CCNPP3COLA PEmails

From: Steckel, James
Sent: Thursday, November 04, 2010 12:20 PM
To: Strout, Steven
Cc: Cook, Christopher; Cruz, Zahira; Wang, Weijun; CCNPP3COL Resource
Subject: RE: Meeting attendees
Attachments: image001.png; image002.png

A telecon was held on Wednesday, November 3, 2010, at the request of UniStar for clarification of RAI 268 (eRAI 5120), Question 02.05.04-27 – settlement calculation 2. The applicant’s technical support contractor wanted to understand how the Cam-Clay model, used in the staff’s confirmatory calculation, was calibrated on the available tri-axial stress-strain data. Staff were not able to provide sufficient detail without input from the support contractor that conducted the confirmatory calculation. Staff was able to reach the contractor after-hours and received clarifying information, attached to this email. Staff and applicant representatives will hold an additional telecon Thursday afternoon, November 4, to continue the discussion.

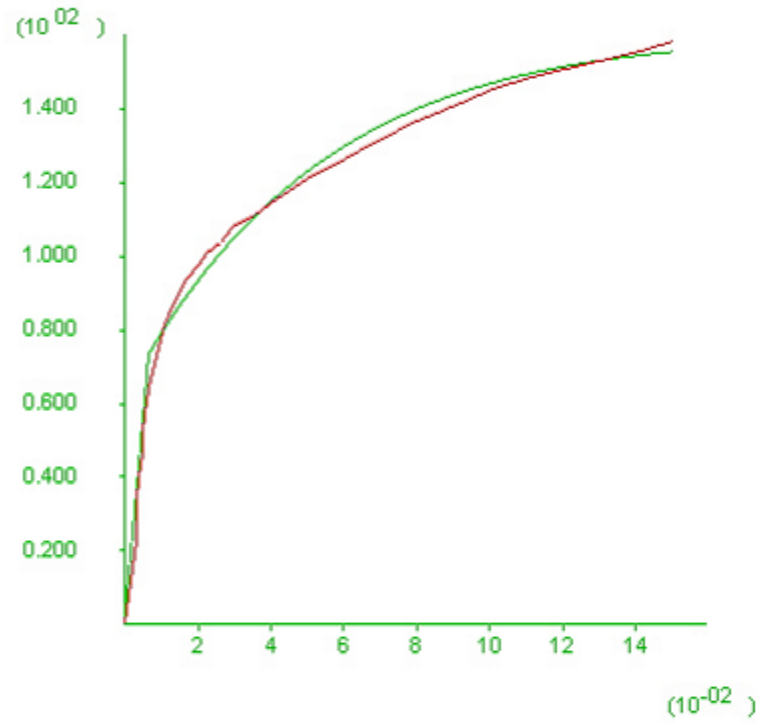
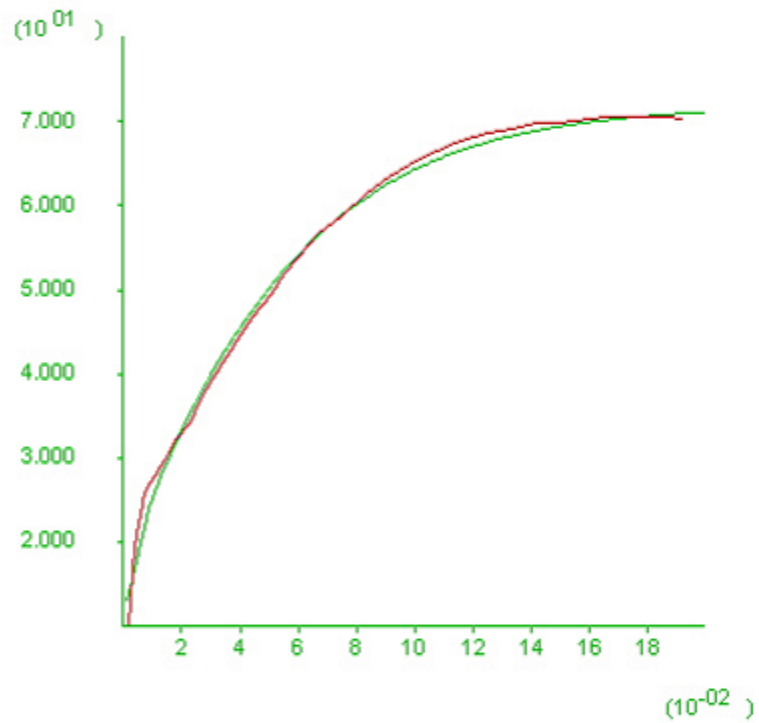
“We basically started with consolidation data provided in the calculations (which are inputs form the cam-clay model) and adjusted those parameters for a single finite element until the computed stress-strain behavior matched the test data. I have attached some figures that show this match.”
